July 7, 2011

#### RE: O'Kane Property, 4825 Wharff Lane, Percolation Certification Plan comments

RE: O'Kane Property proposal (SDP-12-013), Health Department comments

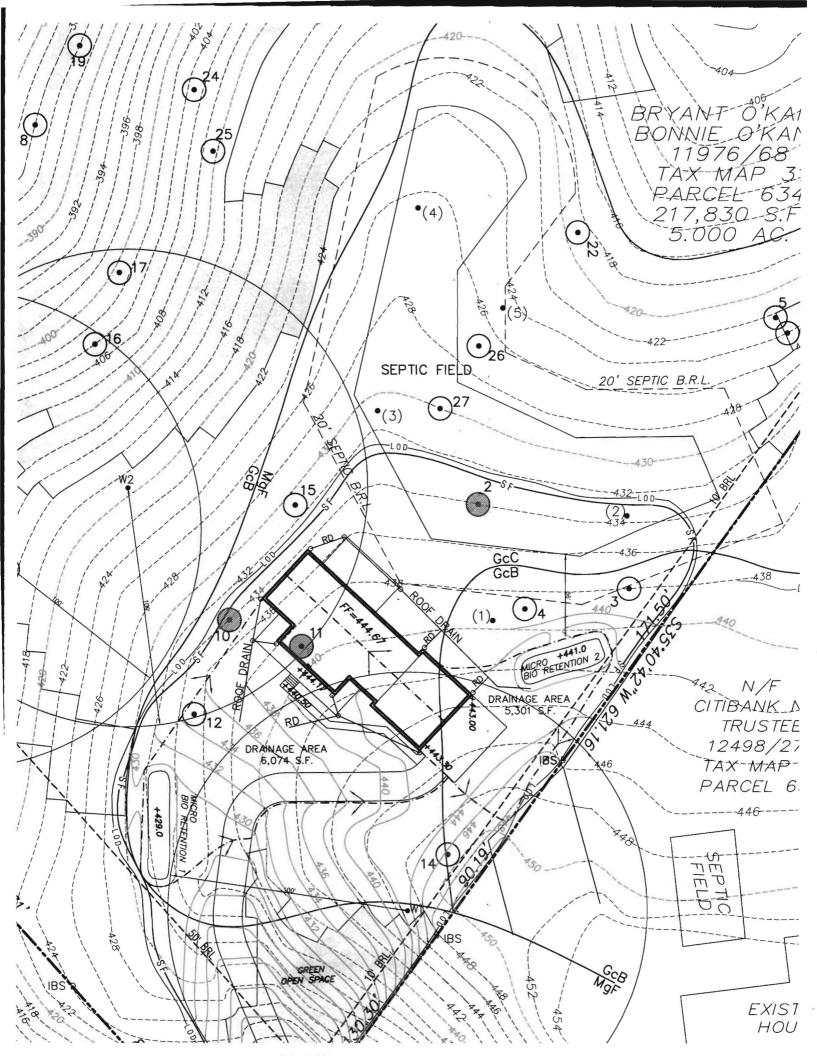
- 1. Show the sewage disposal area, and/or the septic tank and distribution location(s), and the well for 4835 Wharff Lane.
- 2. Proposed well locations 'W2' and 'W3' are on slopes too steep for a drill rig. Place these locations (separated by at least 50 feet) on the lesser slope to the northwest of current 'W3' location.

- 3. Show a 100-foot radius around each existing and proposed well.
- 4. The micro-bioretention basin must be 100 feet from any existing or proposed well.

- 5. Add more shading or darkness to the symbol for slopes > 25%.
- **6.** The soil map unit labels are not all properly placed. Check the placement of labels and correct as necessary.

- 7. Use the exact symbol in the LEGEND for percolation test as is shown on the plan.
- **8.** In the LEGEND: add a symbol for soil map unit delineation.

- 9. A 20-foot BRL for the septic reserve is shown, though it is not necessary.
- **10.** The Health Officer signature block is conditioned with this phrase only: "APPROVED FOR PRIVATE WATER AND PRIVATE SEWERAGE SYSTEMS".

- 11. Include your certification statement in a block as preparer and sign the certification statement, or place your seal next to the certification statement and sign your seal.

- 12. The first four Notes are appropriately stated. Concerning the sewage disposal area statement: place it in a prominent location on the plan and add a box next to it showing the symbol utilized.

- 13. Add a purpose statement.

THE PURPOSE OF THIS PLAN IS TO ESTABLISH A SEWAGE DISPOSAL AREA AND WELL RESERVE FOR (TAX MAP 31) PARCEL 634.

14. Add these Notes

THE WELL TO SERVE THE PROPOSED RESIDENCE SHALL BE DRILLED AND THE WELL COMPLETION REPORT APPROVED BY THE HEALTH DEPARTMENT PRIOR TO BUILDING PERMIT APPROVAL.

INSTALLATION OF SEPTIC DRAINFIELD LINES REQUIRES DISRUPTION AND DISTURBANCE OF SOIL AND SOIL ORGANISMS, AND LIKELY WILL RESULT IN DAMAGE OR DESTRUCTION OF TREES AND OTHER VEGETATION WITHIN THE DEFINED BOUNDARIES OF THE SEWAGE EASEMENT.

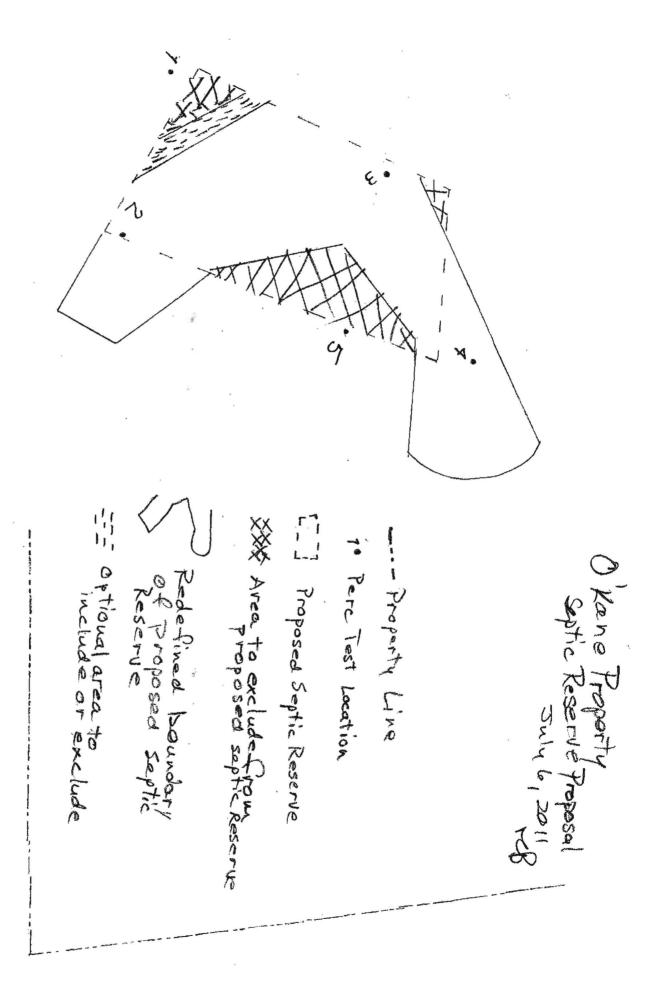
In reference to the draft perc cert you submitted, I have found that you represented the location and dimensions of the formerly proposed septic reserve fairly accurately. I also found that you represented the perc locations accurately with regard to the information contained in documents maintained by the Health Department.

A field review is required for a thorough assessment of your proposal. So that I have accurate reference points, I need for you to stake the 5 perc test locations that you have indicated on the submitted plan. Send a notice to me when the stakes are in place.
